# Groundwater Transfer Review Summary Form

Transfer/PA # T- 13140

Application: T-13140 (TEMPORARY)

Applicant Name: Gold Ring Holdings, LLC

Well Location Map

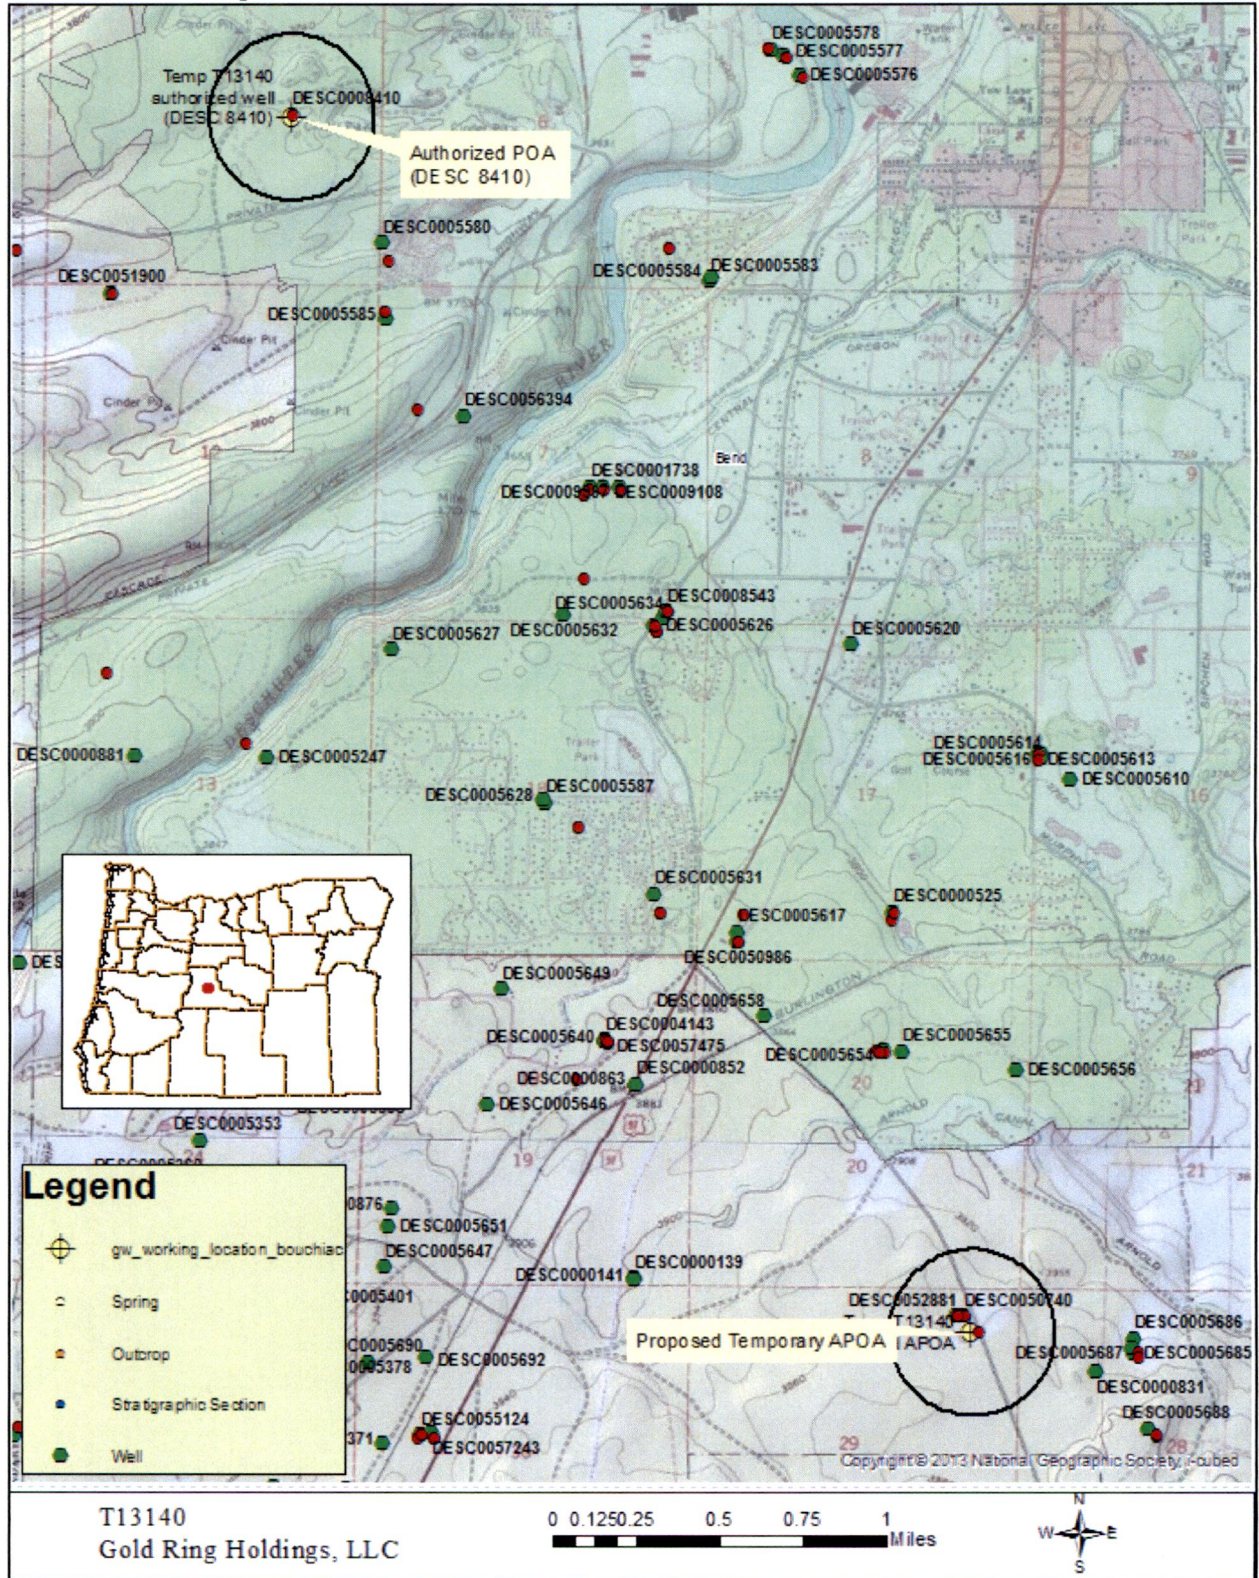
- 4. a) Will this proposed change, at its maximum allowed rate of use, likely result in an increase in interference with **another ground water right**?  
 Yes     No    Comments: This transfer would move groundwater production closer (from approximately 4-miles to less than approximately 400-feet) to the existing China Hat wells (DESC 50740 and DESC 52881). The existing China Hat wells are included in permits G-9217 -9269, -9320 -9946, -9948, -9971, -9975, -9976, -16025, and -17539 and on Certificates 84975, 86161, 87382, and 88551 – all owned by Avion.

Yes  No If yes, explain: It is extremely unlikely that the entire 2.7 cfs could be produced from a single well at either the authorized well or the proposed APOA. The wells near the China Hat site produce on average approximately 500 gpm based on driller's well logs. The proposed APOA is in relatively close proximity to the existing China Hat wells, so interference could be an issue if careful observation and management are not observed. However, all the water rights authorizing the existing China Hat wells are for the Avion Water Co, and this application is to supply for the Avion service area.
